Appendix 1 – Commerce Commission request for additional information

ROX-ISL A Line

Four Day Outage, Cut-in new 3 km section of conductor

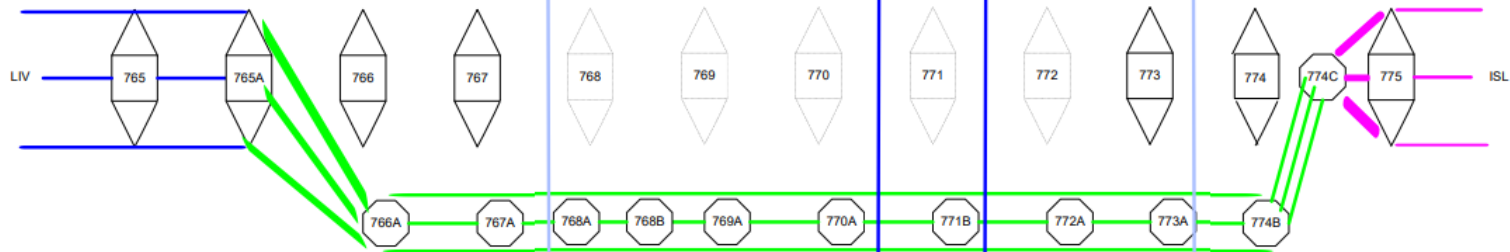
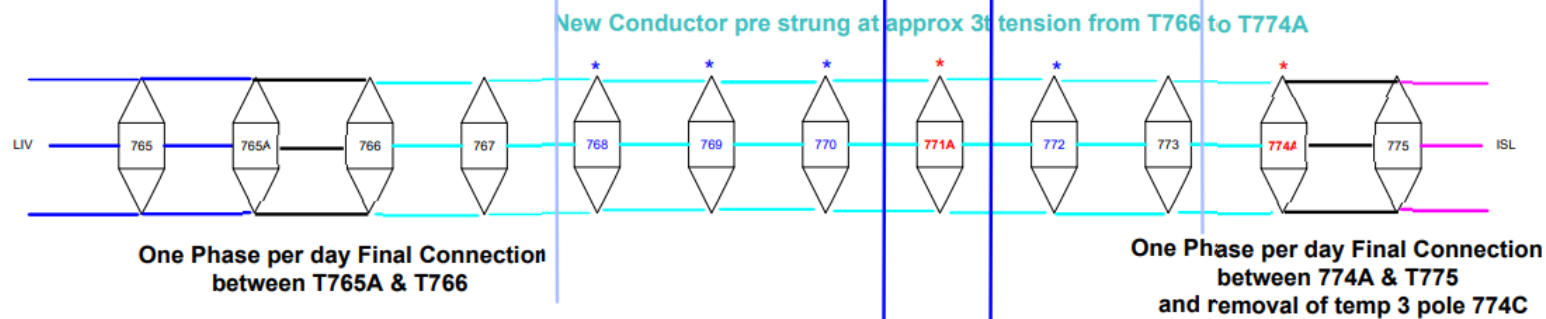
- a) **Please provide further details on the need for a 4-day outage to reconnect the line to the permanent structures. For example, advise what works had to be carried out during the outage and which of the works had to be done sequentially (ie the package of work could not start until another package of work was completed).**

Three days were required for trans-positioning the three phases of sub-conductors. This was completed as planned, targeting one phase per day due to the shorter daylight hours in August. Each phase had two sub-conductors.

The diagram on the next page provides further detail. The two wiring spans (Tower 765A-766 and Tower 774A-775) for connecting the 3km section of new line were simultaneously worked with two separate crews. Each crew had to maintain the existing conductor tensions from Tower 765A-775, while also maintaining the new conductor tensions from Tower 766-774A. This required engineered controls to sequentially manage loads to the temporary poles and permanent tower structures. These controls included step processes and hold points for construction activities.

The trans-positioning necessitated each sub-conductors' tension to be held and lowered for new sub-conductors to be raised, brought up to pre-tension, sagged and terminated. This occurred for each phase.

The fourth and final day involved installing spacers, removing temporary earths, completing pre-commissioning inspection and function checks before carrying out the commissioning of the ISL-LIV-1 circuit.

The diagram on the next page shows the complexity involved in returning the permanent line to service. The need to maintain mechanical tensions to either side of the temporary pole structures is unique in nature.
